Administrative Approval Action

Case File / Name: ASR-0087-2023

PARKSIDE APARTMENTS - AFFORDABLE HOUSING

- LOCATION:** This 4.9 acre site zoned RX-4-PL CU (Z-11-23) and within an SRPOD overlay is located on the east side of the intersection of Cyanne Ct and Kent Road at 1329 Kent Road.
- REQUEST:** Development of an affordable-unit community consisting of three four-story multifamily apartment buildings with 144 dwelling units, surface parking, an amenity center and associated infrastructure. Total proposed building space is 203,675 square feet.
- DESIGN ADJUSTMENT(S)/ALTERNATES, ETC:** N/A
- FINDINGS:** City Administration finds that this request, with the below conditions of approval being met, conforms to the Unified Development Ordinance. This approval is based on a preliminary plan dated May 1, 2024 by Kylie Howe.

SL1.00

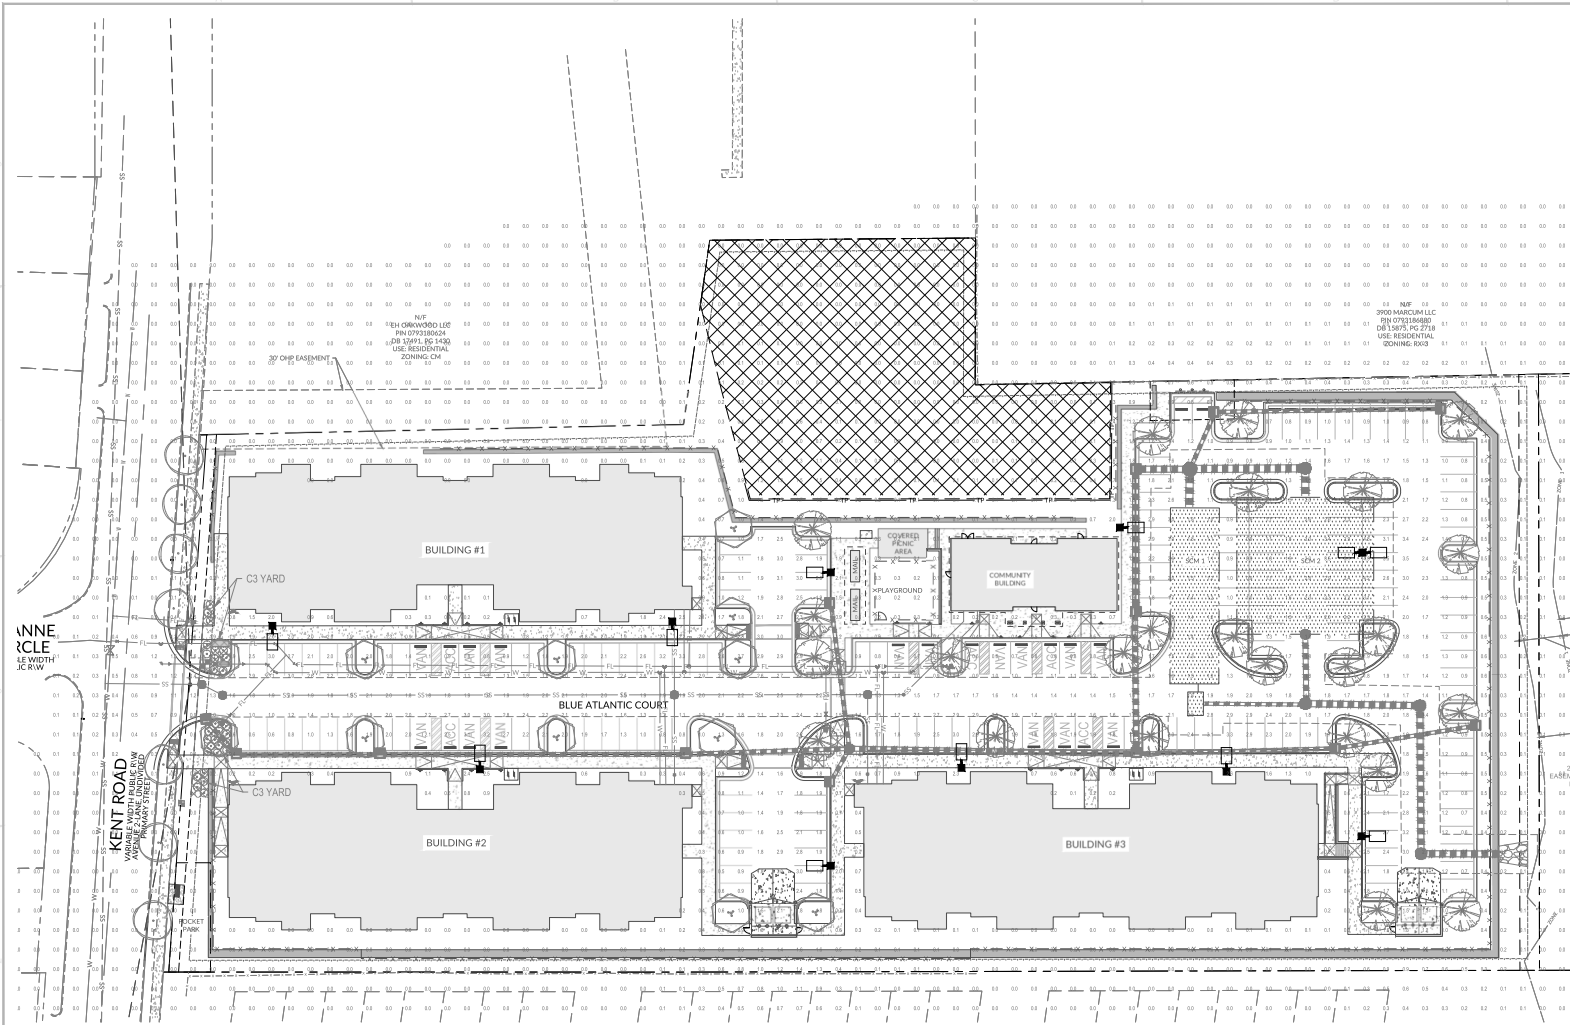
3. See Sheet SL1.00- lighting plan - on the plan sheet please clarify that the pole height is < 30' as required by section 7.4.5 a of the Unified Development Ordinance. demonstrate compliance on pla
